## RFI question and design team response

**GAMEDAY**  
190 Creekside Crossing,  
New Braunfels, 78130 Texas

# OFFICE DESIGN

**LIFE SAFETY PLAN & SHEET NO.**  
A1.00

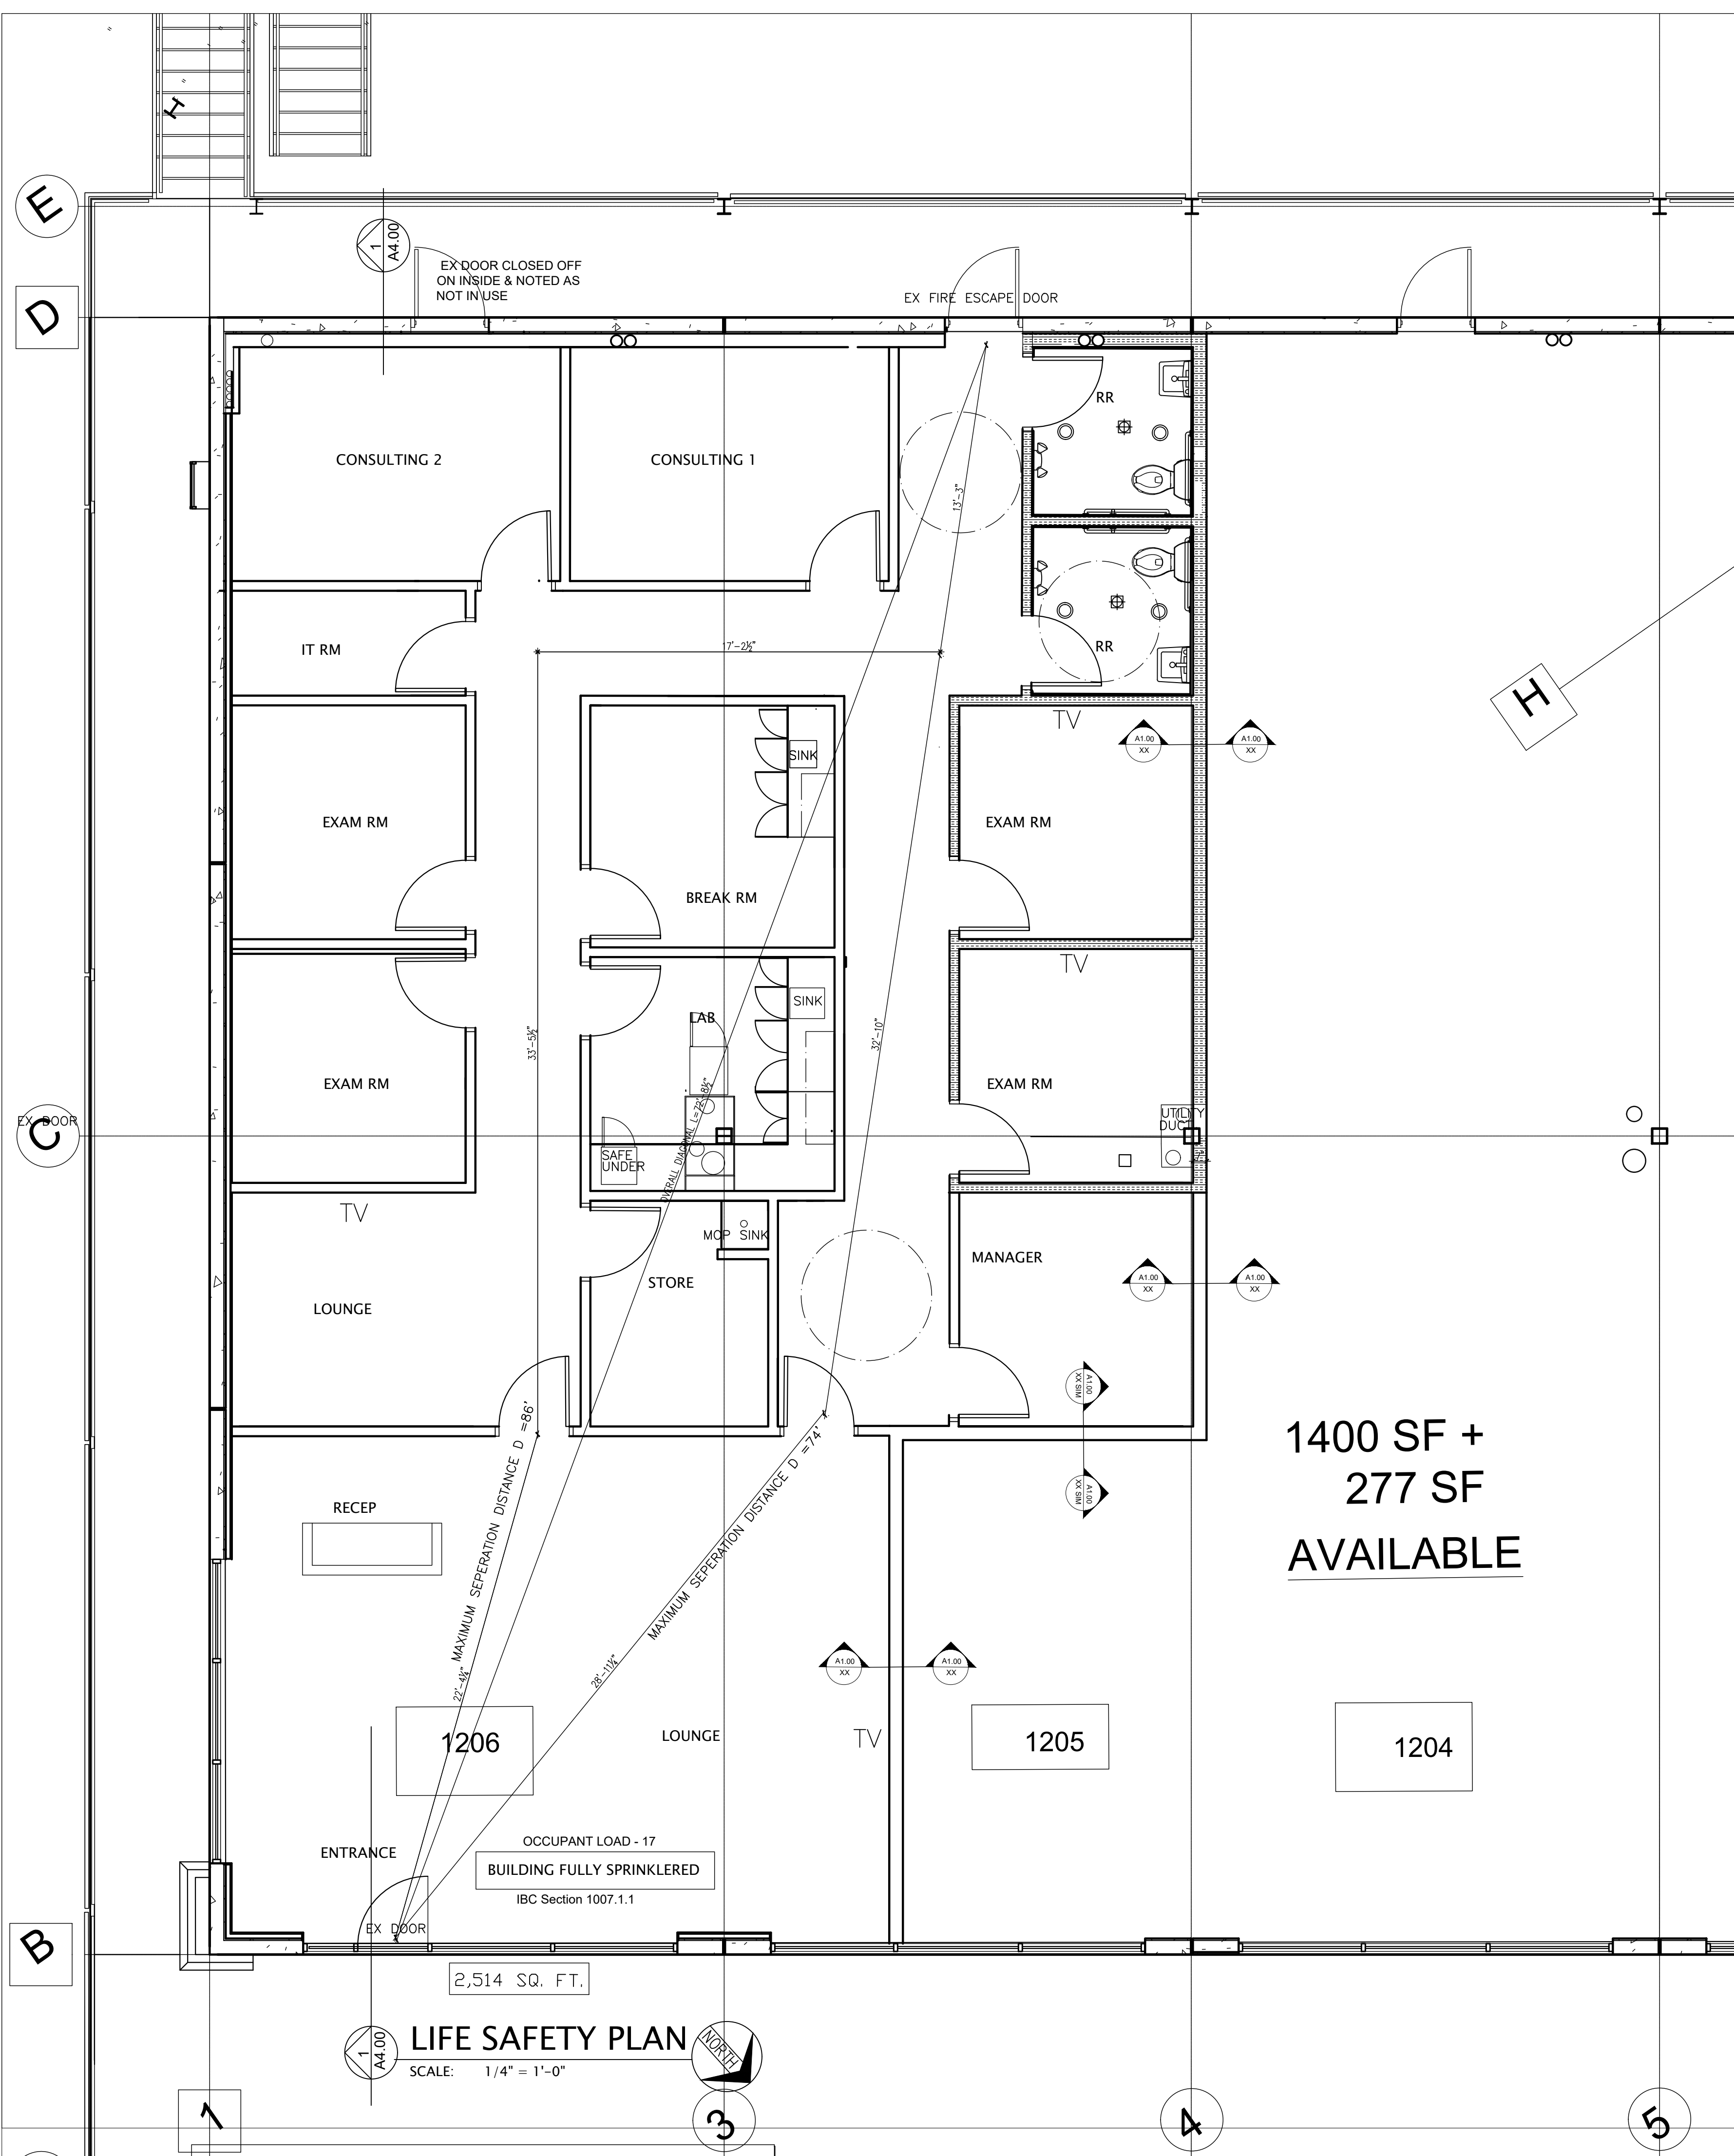
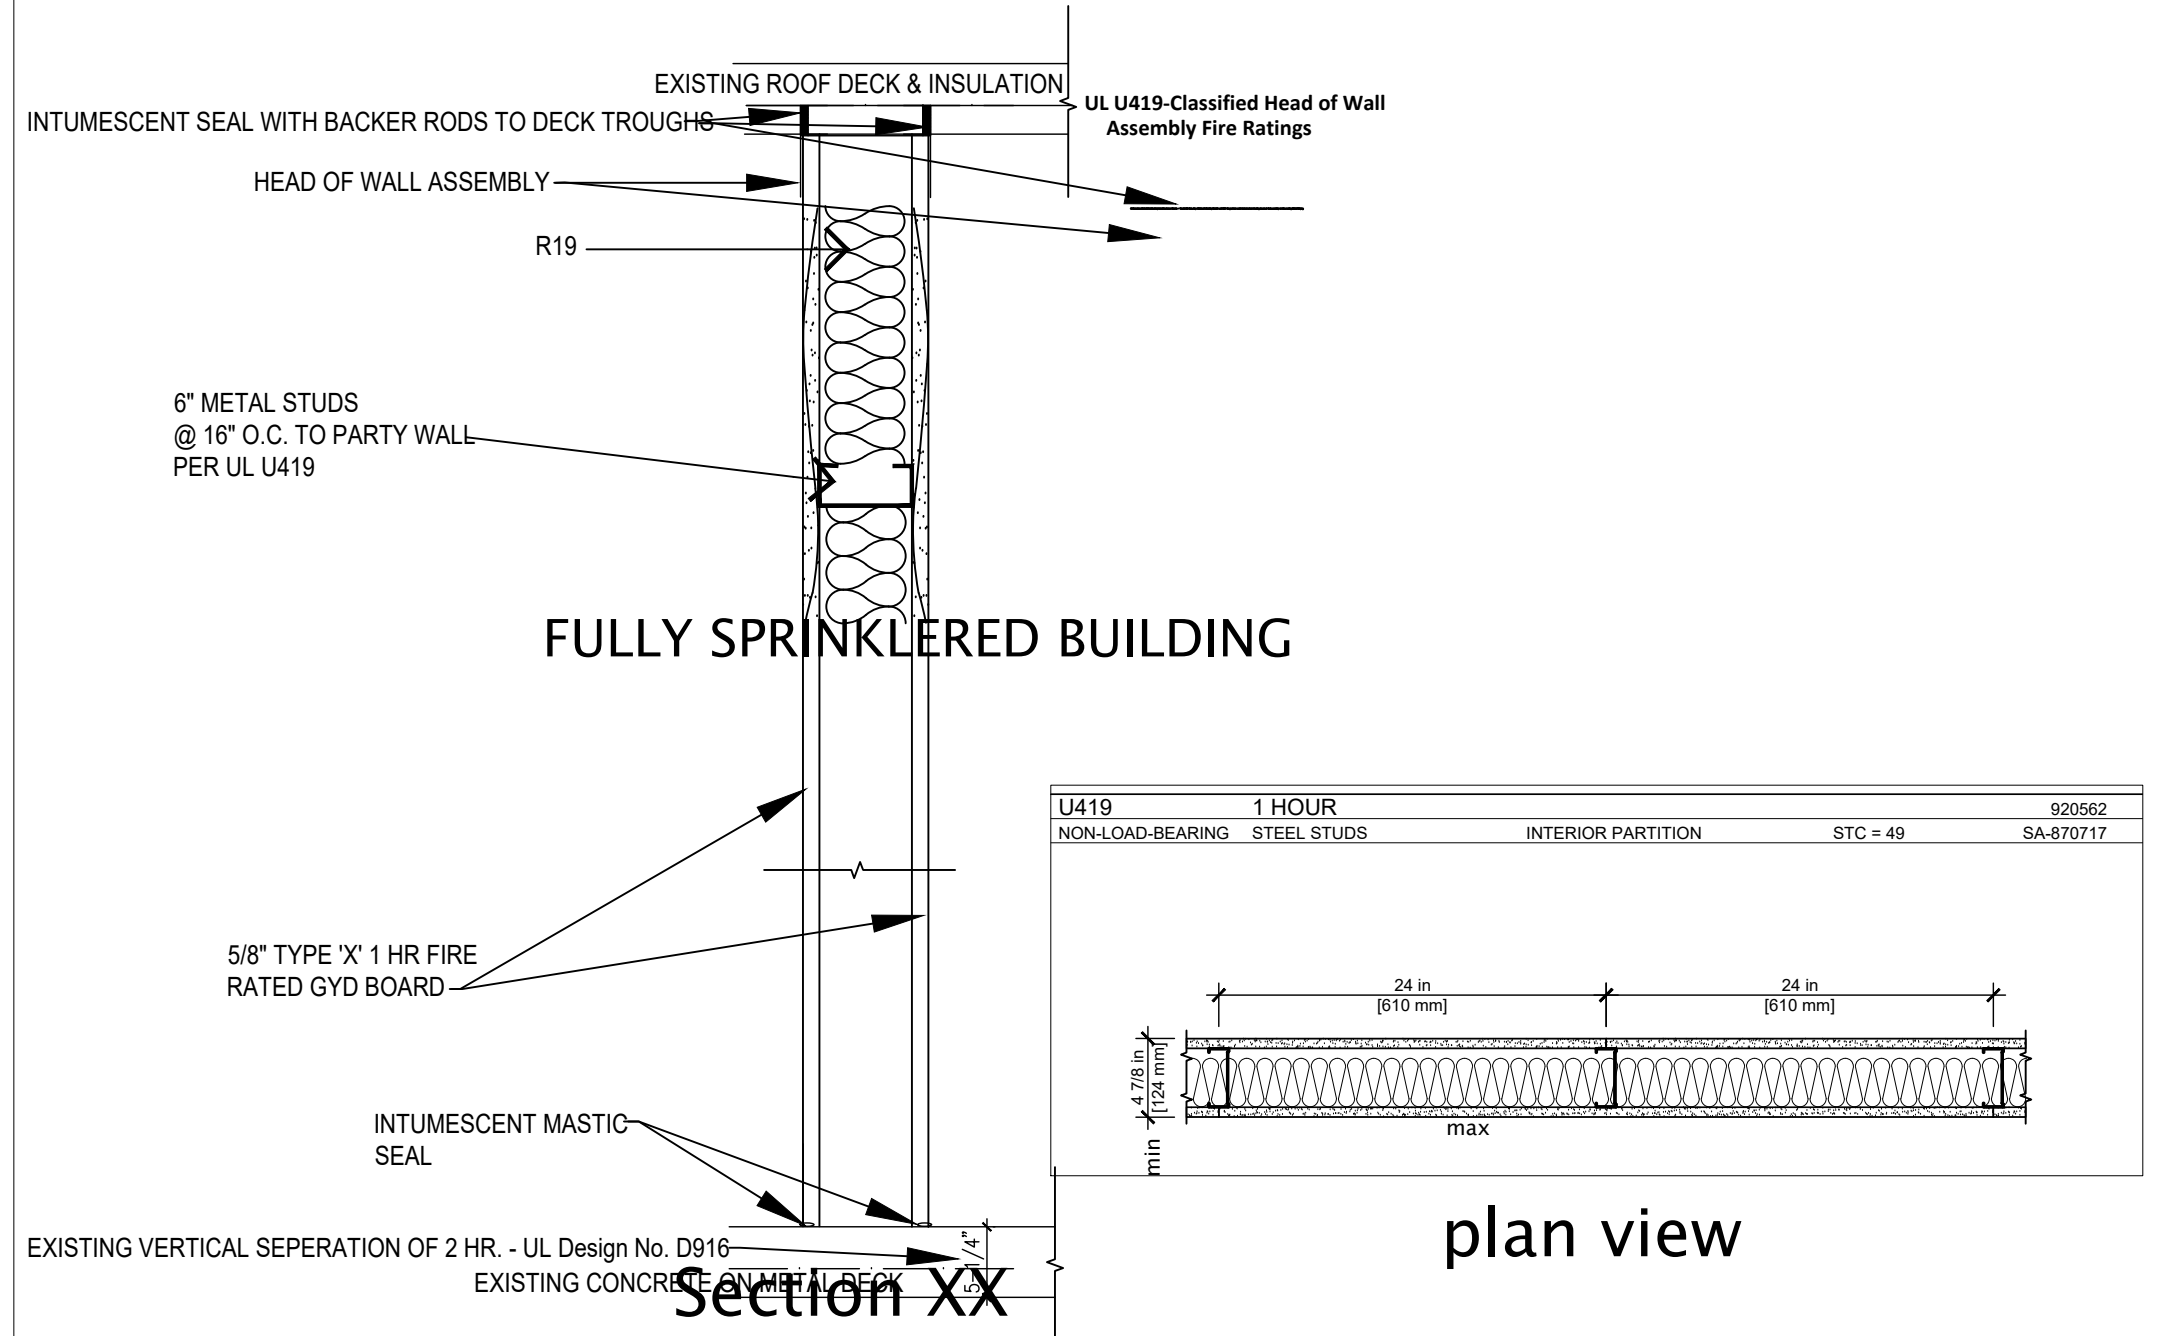
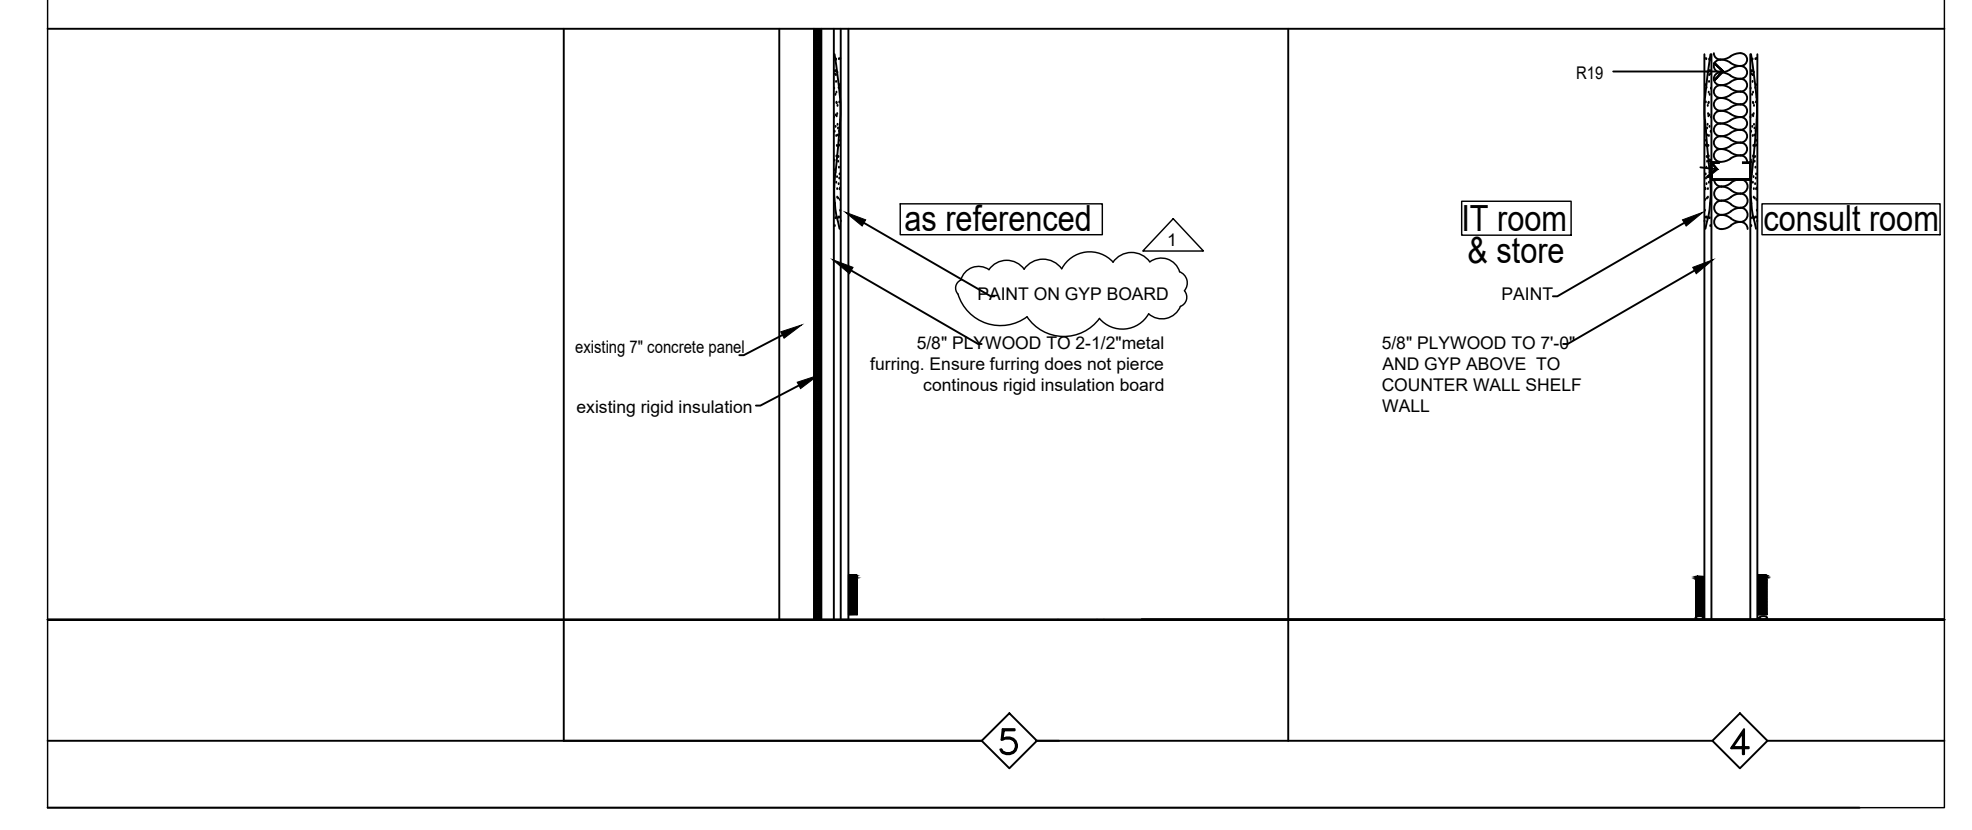
A1.01 on the southeast exterior wall – wall type is indicated to be type 5. This is detailed on A1.00 to be painted plywood? [See attached A1.0 Rev-1](#)

I understand the demising wall is to be to the roof deck, but what is the height of all the interior walls? [See Attached A1.0 Rev 1](#)

Is insulation to be included in all interior walls? [See Attached A1.0 Rev 1](#)

DATE	DESCRIPTION	BY
06.11.26	Demising wall to deck. All other walls to min. 9' above ceiling. R12 to all walls sound attenuation & 2" furring wall. Ceiling insulation throughout except over reception lounge.
